IEEE 802.3at Comment Resolution

#182

Dan Dove Principal Engineer – LAN PHY Technology

IEEE 802.3at Task Force – Denver Colorado – July 2008

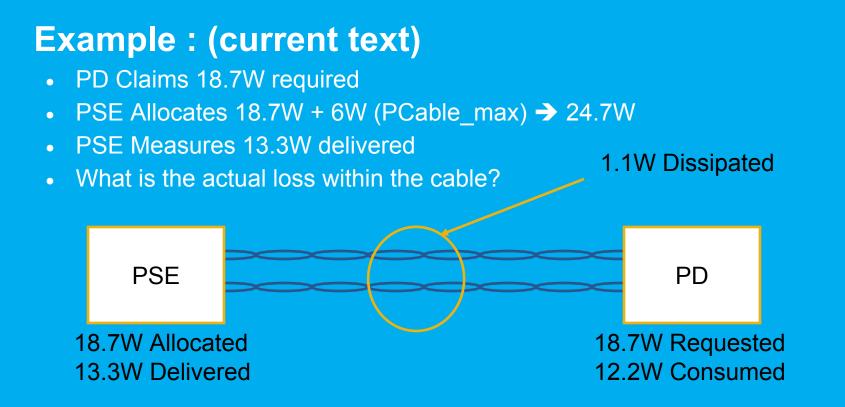
- LLDP is going to allow a PD to accurately define its maximum power requirement
- This accuracy is important because it allows a PSE to retain allocation of power that is not used by the subject PD, and provide to other devices
- The more accurate a PSE can determine PD requirements, the more power it can retain for other devices
- The more accurate a PSE can determine cable loss, the more power it can retain for other devices

- The PSE must not only allocate power for the PD, but for cabling losses
- Computing cable loss is not possible if the PSE does not know what the PD is actually consuming

- The system has no visibility to loss within the cable plant and thus must allocate the maximum possible loss (6W)
- This example shows ~4.9W of wasted power

Example 2: (proposed addition)

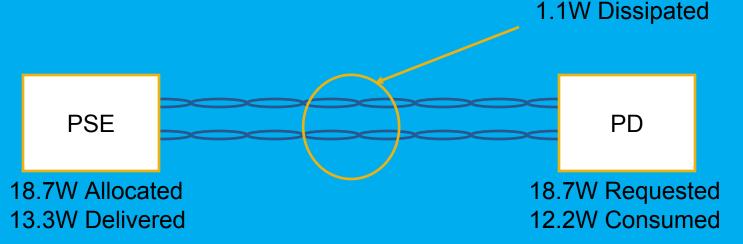
- PD Claims 18.7W required
- PD Claims 12.5W consumed (inaccurate, but helpful)
- PSE Measures 13.3W delivered & computes cable resistance
- PSE Allocates 18.7W + 2.5W (extrapolated loss) → 21.2W

- The PSE has measured the power delivered, subtracted PD actual, and computed cable resistance which allows it to extrapolate loss
- This example shows ability to reduce allocation by 3.5W
- For lower loss cables, computed loss would allow lower allocation values.

Figure 33–26—DTE Power via MDI classification TLV format

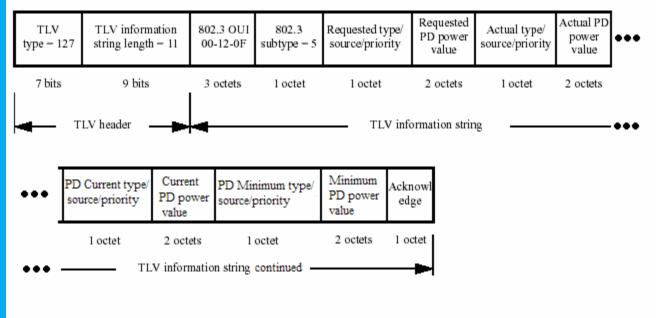
CI 33	SC	33.7.2		P89		L26	# 182		
Dove, Daniel ProCurve Networking									
Comment	Туре	TR	Comment St	atus I	A	Co	nvention & L2 Ne	w Feature	
I believe we need to consider changing the names of some fields, and adding some to provide clarity and functionality that is essential to the spec.									
SuggestedRemedy									
These changes apply here, and in clause 30 - do global search, change									
 Change Requested type/source/priority to "PSE Requested type/source/priority" Change Actual type/source/priority to "PD Actual type/source/priority" Add "PD Minimum type/source/priority" which declares the minimum power the PD can operate with so that a PSE may reduce its power to the minimum without causing it to shut down. Add appropriate sub-clause for definition which includes the value FF = unknown. Add "PD Current type/source/priority" which declares the current power the PD is operating with with so that a PSE may compute loss through the cable by subtracting this value from its own current power distributed. Add appropriate sub-clause for definition which includes the value FF = unknown.

Change to Figure 33-26

Changes to Text: (Renumber & Insert the following)

33.7.2.6 PD current power type/source/priority

The PD current power type/source/priority field shall contain a bit-map of the current power type, source, and priority defined in Table 33–22.

33.7.2.7 Current PD power value

The Current PD power value field shall contain the Current PD power value defined in Table 33–23. The Current PD power value is the average input power (see 33.3.7.2) the PD is currently drawing. This value may be measured, or it may be based upon the state of operation of the PD. If measured or based upon the state of operation, the accuracy of the value provided shall be within 15% of the average power drawn over a one second period prior to transmission of the TLV.

33.7.2.8 PD minimum power type/source/priority

The minimum power type/source/priority field shall contain a bit-map of the minimum power type, source, and priority defined in Table 33–22.

33.7.2.9 Minimum PD power value

The Minimum PD power value field shall contain the Minimum PD power value defined in Table 33–23. The Minimum PD power value is the average input power (see 33.3.7.2) input with which the PD can maintain Data Link Layer communication and any minimal functionality it intends to provide to the user.

33.7.2.10 Acknowledge

The Acknowledge field shall contain a value to indicate the response to the last change in requested power value. The encoding of this field is defined in Table 33–24.
